# SERVICE INSTRUCTION

SI-33-01  
Revision 0

## Strobe Light Connections

**Figure 1 Strobe Power Output Wires Back Shell**

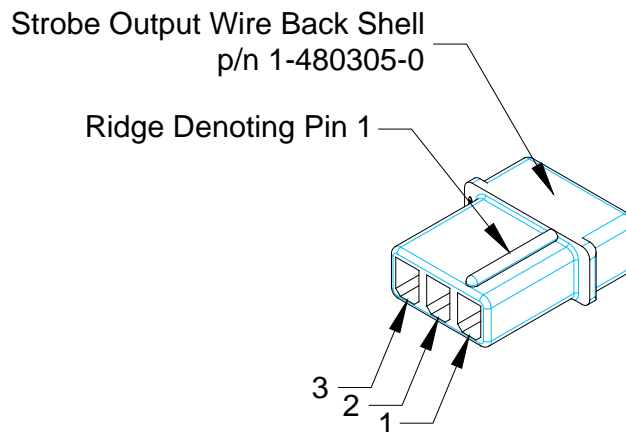
Wires 0511 and 0510 may have been "pinned" incorrectly. The strobes will function correctly, however the flash tube life expectancy may be reduced.

1. Remove port aft interior cabin roof liner to gain access to the strobe power supply.
2. The strobe output wires, (0510 & 0511), are connected to "ALT", (i.e. they are connected to outputs 1 & 2).
3. Verify that the 18 AWG shielded cables are connected as follows: Org/Wht = 1, Blu/Wht = 2 and Wht = 3. Note, the #1 pin is denoted by a raised ridge on the back shell and/or by an embossed "1", see Figure 1.
4. If not, remove wires from the "Commercial "Mate n Lok" back shell and re-pin as required. Refer to Figure 2 below for correct wiring.
5. Service Hint: A very small "jeweler's" standard screw driver may be used to release the "catch tang" of the pins.
6. Reconnect the wires and function the system.
7. Reinstall the port aft cabin roof liner.
